Office Action Summary	Application No. 10/711,842	Applicant(s) REITER, MARKUS	
	Examiner THOMAS W. IRVIN	Art Unit 3657

DETAILED ACTION

Claims 1-3, 5, 7-9, 12, 15, and 16 are rejected under 35 U.S.C. 102(b) as being anticipated by Kamada (6,340,338).

FIG. 12

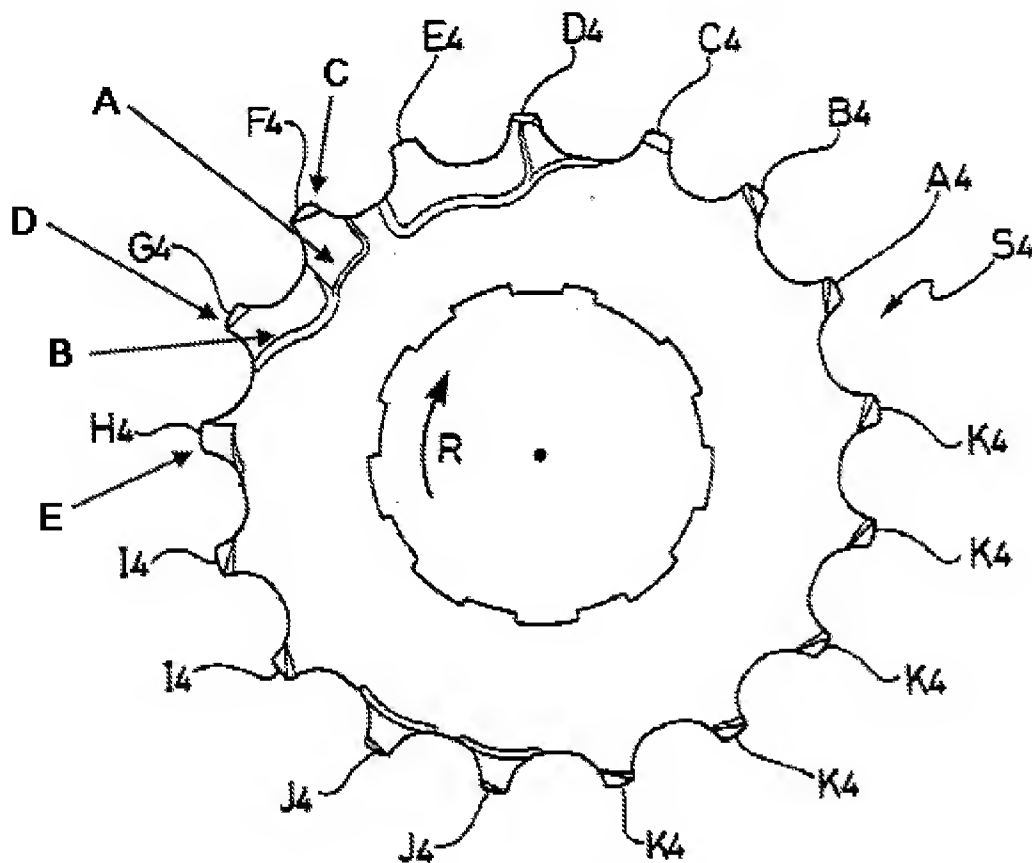
In Re claim 1, with reference to Fig. 3, 13, 14, and 12 (above), Kamada discloses a chainwheel assembly including a plurality of chainwheels (s1-s7) engageable with a chain (23) having successive alternating pairs of inner link plates and outer link plates connected by pins, the pins surrounded by rollers, the chainwheel assembly comprising: at least one smaller chainwheel (s3) having a plurality of teeth spaced about its circumference; and at least one larger chainwheel (s4) having a greater number of teeth spaced about its circumference than the smaller chainwheel, the larger chainwheel and the smaller chainwheel oriented relative to each other such that a distance between a center of the chain roller positioned between a pair of adjacent teeth on the larger chainwheel and the center of the chain roller between a pair adjacent teeth on the smaller chainwheel is substantially an integer multiple of the chain pitch, at least a first tooth (f4) of the pair of adjacent teeth (F4,G4) on the larger chainwheel includes a first lateral recess (A) having a first run-on ramp (see fig. 14), at least a second tooth (G4) of the pair of adjacent teeth disposed adjacent to the first tooth opposite the drive rotation direction including a second lateral recess (B) with a run-on ramp (see fig. 14).

In Re claim 5, see third tooth (H4) which includes a run-out chamfer (E).

In Re claims 8, 9, and 12, see deflection chamfers (C,D) on the first and second tooth (F4,G4) in fig. 12 above.

FIG. 5

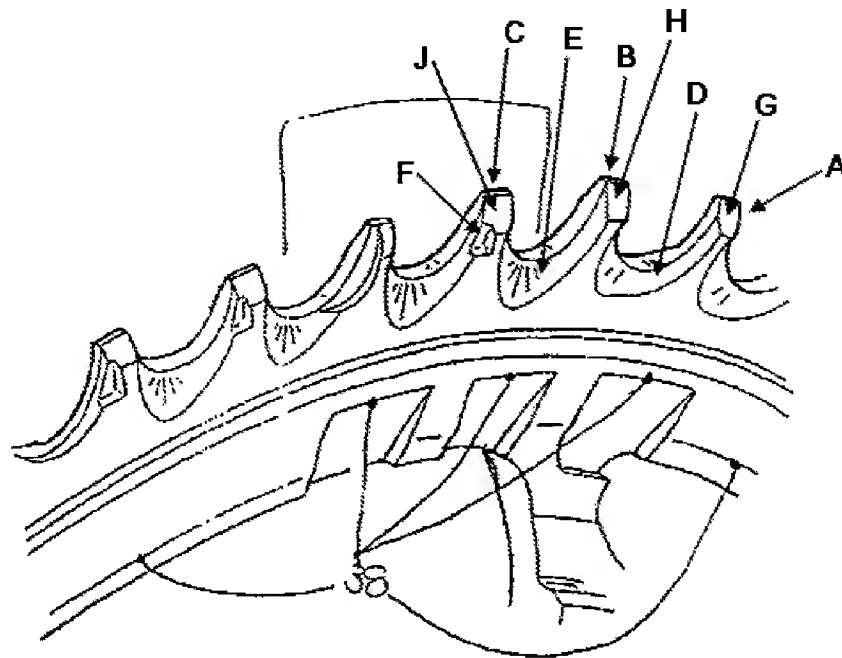
In Re claim 1, with reference to Fig. 5, above, Yahata discloses a chainwheel assembly including a plurality of chainwheels (see fig. 15) engageable with a chain (10), the chainwheel assembly comprising: at least one smaller chainwheel (50) having a plurality of teeth spaced about its circumference; and at least one larger chainwheel (40) having a greater number of teeth spaced about its circumference than the smaller chainwheel, at least a first tooth (A) of a pair of adjacent teeth (A,B,C) on the larger chainwheel includes a first lateral recess and run-on ramp (D), at least a second tooth (B) of the pair of adjacent teeth disposed adjacent to the first tooth opposite the drive rotation direction including a second lateral recess and run-on ramp (E).

In Re claims 2 and 3, see fig. 5.

In Re claim 5, see third tooth (C) which includes a run-out chamfer (F).

In Re claim 7, see fig. 5.

In Re claims 8 and 12, see deflection chamfers (G,H) on the first and second tooth (A,B) in fig. 5 above.
